Risk-Informed Extension of the Reactor Vessel Nozzle Inservice Inspection Interval

UNITED STATES
NUCLEAR REGULATORY COMMISSION
WASHINGTON, D.C. 20555-0001

SUBJECT: FINAL SAFETY EVALUATION FOR PRESSURIZED WATER REACTOR OWNERS GROUP TOPICAL REPORT WCAP-17236-NP, REVISION 0, 'RISK-INFORMED EXTENSION OF THE REACTOR VESSEL NOZZLE INSERVICE INSPECTION INTERVAL' (TAC NO. ME4878)

Figure 3-3 Nozzle Weld Configuration Types

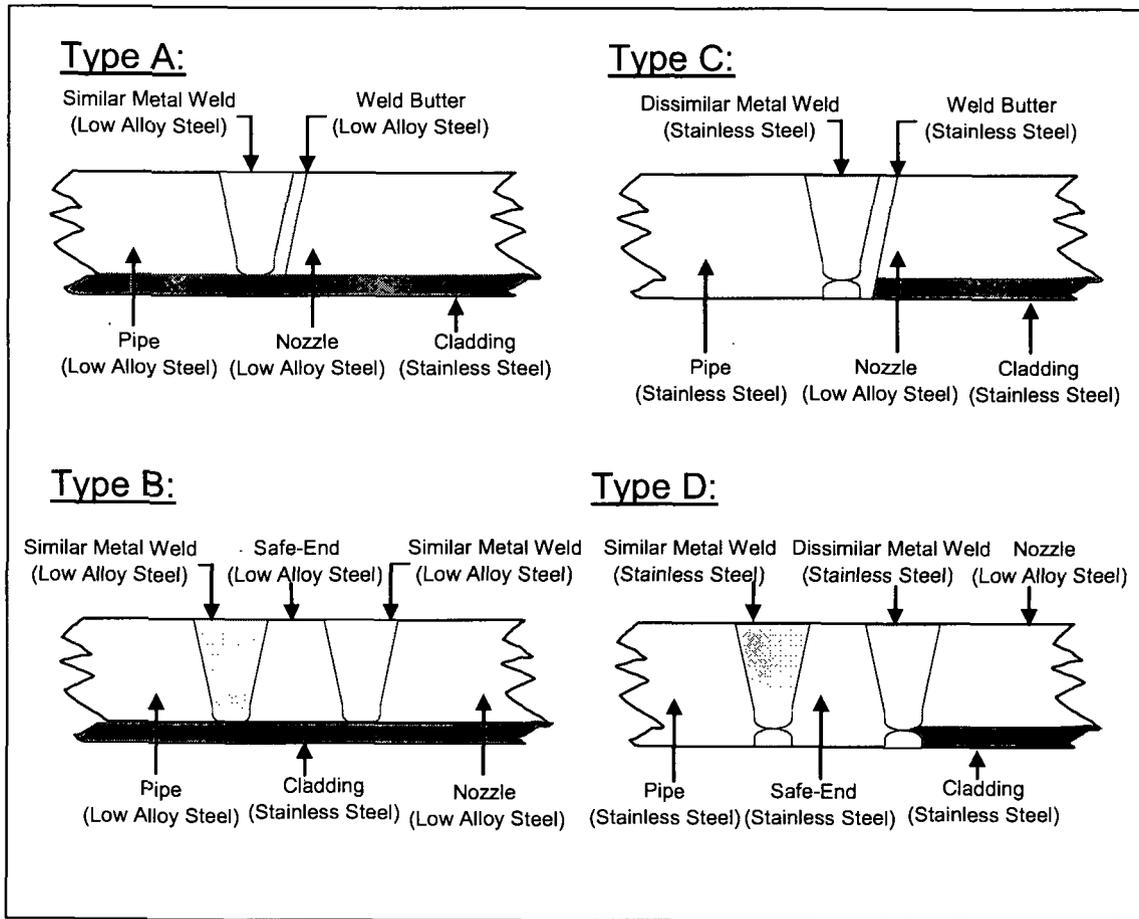
DCI-RAI-6 *Figure 3-3 of TR WCAP-17236 shows schematics of the four RV nozzle weld configurations. In reality, the diameter varies from the nozzle to the pipe. Identify the diameter that the PWROG used as input to the SRRA Code (nozzle diameter, pipe diameter, or something else) and justify the selection.*

DRA-RAI-2 *Tables 2-1 and 3-9 (and other tables) of TR WCAP-17236 direct that the change in risk includes a multiplier characterized as "(# of welds examined)." Figure 3-3 illustrates the different nozzle types where it appears that weld Types B and D have two welds per nozzle implying that the frequency results for these types of welds should be multiplied by 2. Other discussion and examples in TR WCAP-17236 imply that a frequency estimate is developed for each nozzle, not each weld in the nozzle. Is the "(# of welds examined)" more appropriately labeled "(# of nozzles examined)"? If not, please clarify what the relationship is between the (# of welds examined) and the number of welds in a nozzle.*

The response to DCI-RAI-6 clarified that the input of RV nozzle diameter may not reflect the real nozzle geometry. Instead, "all grouping of thickness and diameter inputs were evaluated...the grouping that provided the highest change in failure (MLOCA) frequency between 10-year and 20-year inspection intervals was selected as being limiting for that nozzle type." Therefore,

DCI-RAI-6 is resolved because the PWROG's approach of using the nozzle geometry that gave limiting results is conservative. Response to DCI-RAI-7 clarified that regardless what the SRRRA input on flaw was called, "the SRRRA Code simulate a maximum of one flaw at the worst stress location that could result in the first failure of the nozzle weld." Therefore, DCI-RAI-7 is resolved because the PWROG's approach of selecting the worst stress location for evaluation is conservative.

In order to calculate the change in risk for a specific plant, the number of welds examined must be multiplied by the summed changes in CDF and LERF results for all three failure modes (LOCA leak rates) as described in Section 3.2.4 of the TR. This change in risk is determined on a per weld examined basis and not a per nozzle examined basis. If there are two welds within a single nozzle and both of these welds are examined, then they must be included in the change-in-risk calculation. For example, if a 3-loop plant with Type D nozzles, as illustrated in Figure 3-3

"Therefore, for nozzle configurations (see Figure 3-3 in Section 3.2.3) where there are two welds per nozzle, the change in risk added to the change in risk from the RI-ISI element selection should be calculated based on one weld per nozzle."

Figure DCI-RAI-2-2 – Flow Chart for Piping Weld Failure Modes (from Reference 4)

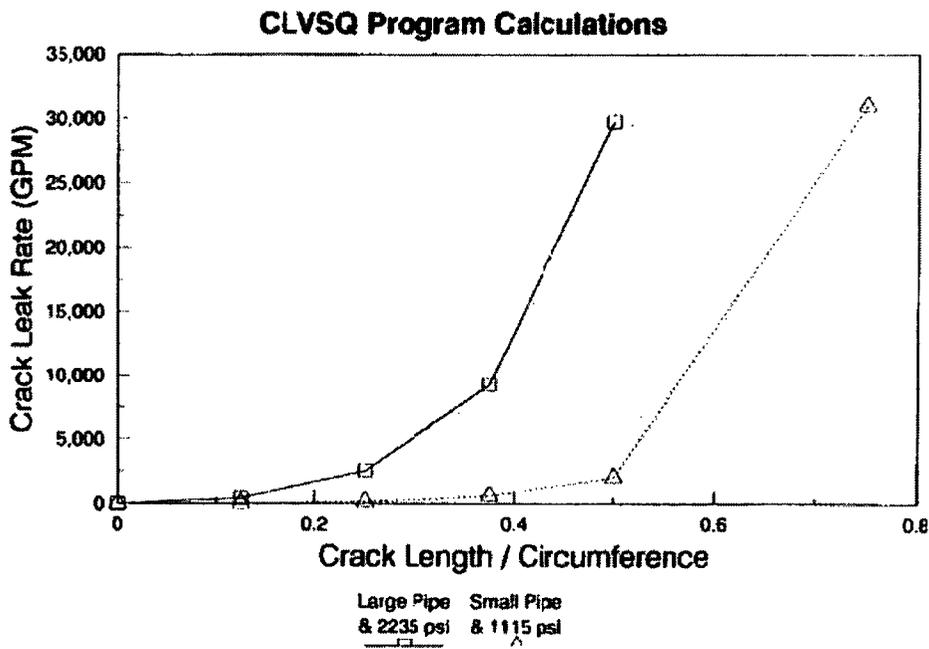
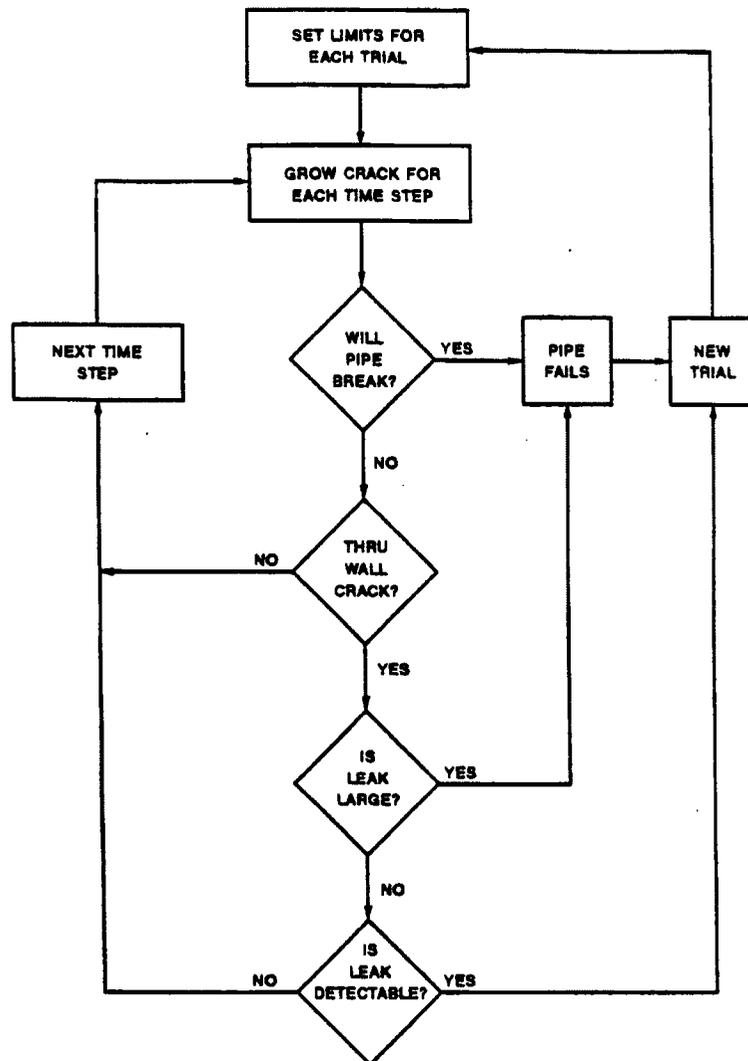
Since the TR contains no details of the PFM methodology used in the application, DCI-RAI-2 requested the PWROG provide a summary of the PFM analysis methodology used in the TR, including the analysis methodology type (elastic plastic fracture mechanics or linear elastic fracture mechanics), failure criteria, and the growth law for a flaw with an initial flaw depth to a critical size or through-wall flaw, and eventually to a long flaw corresponding to SLOCA, MLOCA, or LLOCA. DCI-RAI-2 also requested information regarding the establishment of fracture toughness and other material properties critical to failure resistance for each of the two failure periods for the RV nozzle welds and the key parameters which affect through-wall flow leakage, the leakage that is considered detectable, and how leak detection was credited.

The PWROG provided a summary in the August 26, 2011, response covering all aspects of the PFM analysis methodology that the NRC staff mentioned in DCI-RAI-2. This PFM analysis methodology was used in supporting the approved TR on PWROG RI-ISI for piping (Reference 3). The summary helped the NRC staff accept the inputs for the current application to the SRRA Code and identify additional conservatism in the PFM analyses, such as the surface flaw assumption and the instant change from a semi-elliptic flaw to a circular through-wall flaw when leaking starts. Due to low neutron fluence and benign coolant condition, fatigue crack growth was identified as the only growth mechanism of concern in this application. The interface of leakage determination and PFM analysis is also consistent with the industry

How leak detection is credited is best shown in Figure DCI-RAI-2-2 (Figure 2-3 in the SRRRA Supplement, Reference 4). For each random trial, the initial flaw size and crack size for a full break due to ductile rupture are set and the crack grows in depth and length due to the fatigue loading (stress range and number of cycles) for each time step, which is one year of operation. The growth in both directions to a through-wall flaw, and only in the length direction thereafter, was previously discussed in the Responses to Parts 1 and 2 of this RAI, respectively. Because a break due to ductile rupture from application of the design limiting stress could occur without a through-wall flaw, it is checked first to determine if failure occurs, and if so a new trial is initiated. If it does not fail, a check is made to determine if the flaw has grown through the wall. If not, the crack is grown for additional years of operation until 40 or 60 years is achieved and a new random trial is initiated. If it is through the wall, the length is checked to see if it will cause the specified large leak rate, such as that for a small, medium or large LOCA, and if so the pipe fails. If not, the crack length is checked to see if it exceeds that for a detectable leak of 1 GPM. If the leak is not detectable, the crack grows for another year due to fatigue loading and is then checked again for breaks and large leaks. If the leak is detectable, there is no failure and a new random trial is initiated.
